Work Order ID 77412

Item Name: Crosstube Fwd

DART AEROSPACE LTD		Work Order:	77412
Description: Crosstube High Fwd (205/212/412)		Part Number:	D212-664-101
Inspection Dwg: D212-664-141	Rev: D	Page 1 of 1

DRAWING NO. D212-664-141	TITLE XTUBE ASSY (205/212/412 HI FWD)	REV. D	DART AEROSPACE LTD ENGINEERING ORDER		D.E.O. NO. D212-664-141-D-1	SHEET NO. SHEET 1 OF 2	SCALE NTS
DRAWN	CHECKED	MP	MFG. APPR.	RE	APPROVED	NA	DE APPR.
DATE 11.04.07	DATE 11.04.11		DATE 11.04.12		DATE 11/04/12		DATE 11.04.12

**D212-664-141/-141B
ASSEMBLY DETAIL**

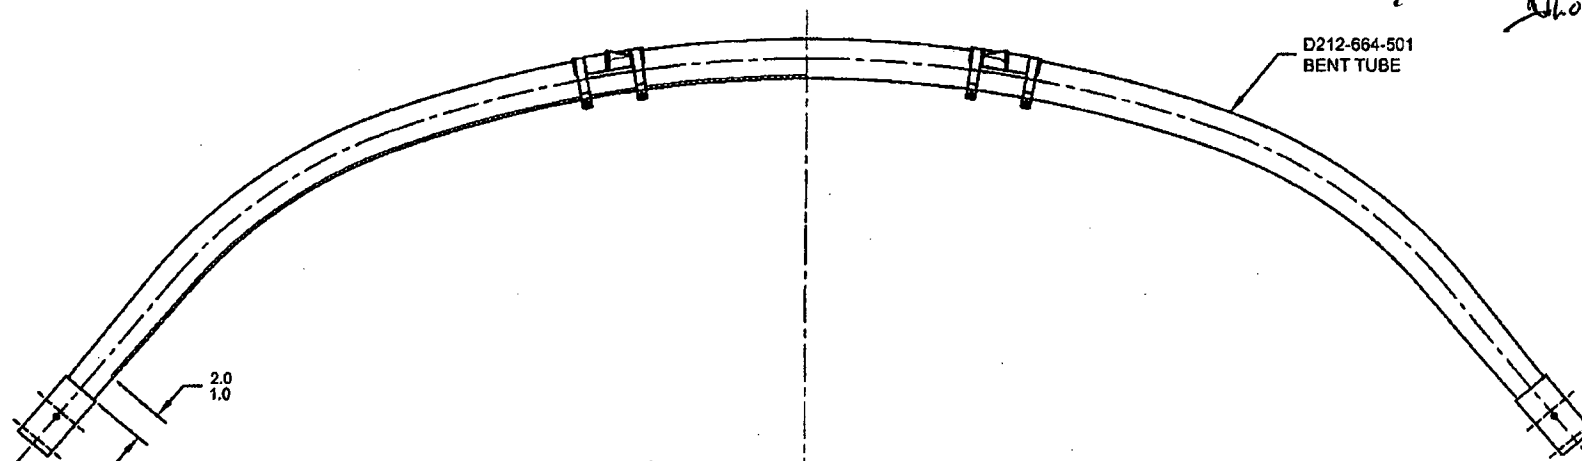
ADD AN INSPECTION WINDOW TO UNDERSIDE OF CROSSTUBE.

IS:

WAS:

MASK AREA PRIOR TO PAINTING,
REMOVE MASKING AFTER PAINT
AND APPLY CLEAR COAT
